- A. Vapor Lock Problem * Model 40 and 402
- B. Cracked Cap Style Connecting Rods * Model 40/70/80/90/ 115
- C. Retorquing of Cylinder Heads * All V-6 Outboards
- D. Drive Shaft Usage Part Number 45-69251 * 6 Cylinder In-Line 140/1500
- E. New Service Tools for 1984 Model 75/90/115 with Power Trim
- F. Model 80-200 * Ignition Coil Test Procedure

NUMBER: 84-1

Figure 1. Cracked Cap Style
Connecting Rod

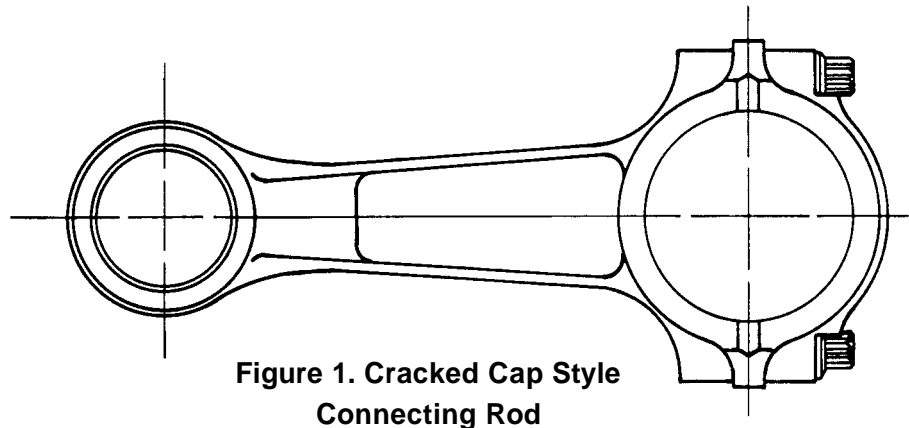
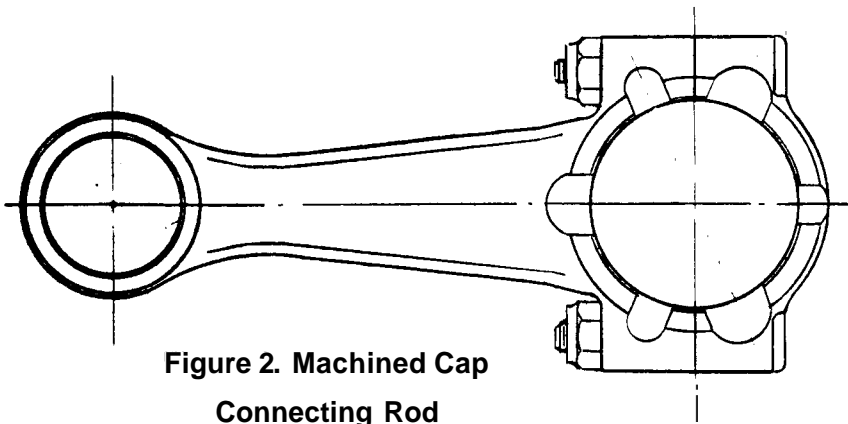
Current model 40/70/80/90/115 outboards are now using the cracked cap style Connecting Rod, Part No. 624-8101A3, Figure 1.

The cracked cap style Connecting Rod, Part No. 624-8101.43 supersedes and will backfit for Connecting Rod, Part No. 622-4850A3 (Figure 2) for all applications. DO NOT, however, use the old machined cap rod, Part No. 622-4850A3 in any current engine using the new cracked cap rod. The new rod extends bearing life considerably.

Figure 3.

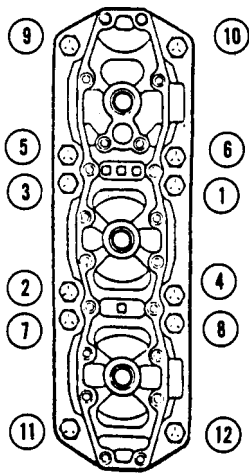
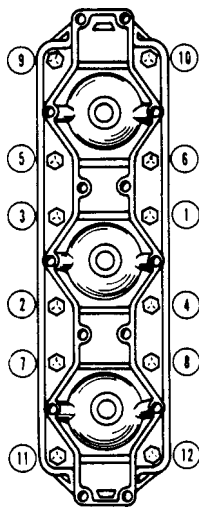
Type 1
 40 Lbs. Ft. (54.2 N.m)
 Add Light Oil to Threads

Type 2
 30 Lbs. Ft. (40.7 N.m)
 Add Light Oil to Threads

Retorque head bolts after engine has been run approximately 3 hours

Figure 4.

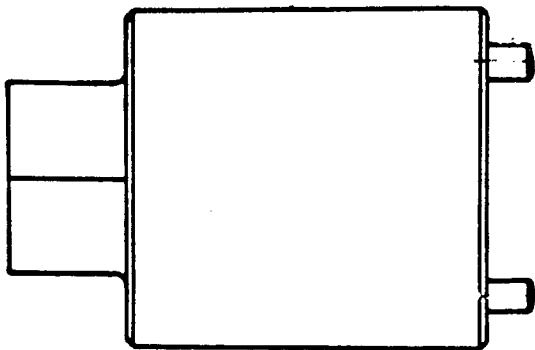
91-44487A1, Trim Rod Guide Removal Tool, Figure 4. Removes the guide assembly from the trim cylinders.

Figure 5.

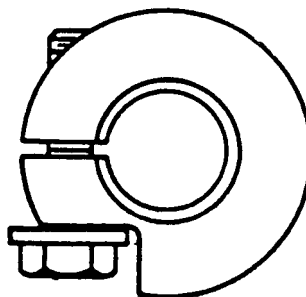
91-44486A1, Trim Rod Removal Tool, Figure 5. Clamps onto the trim rod to grip rod and aid in removal from cylinder.
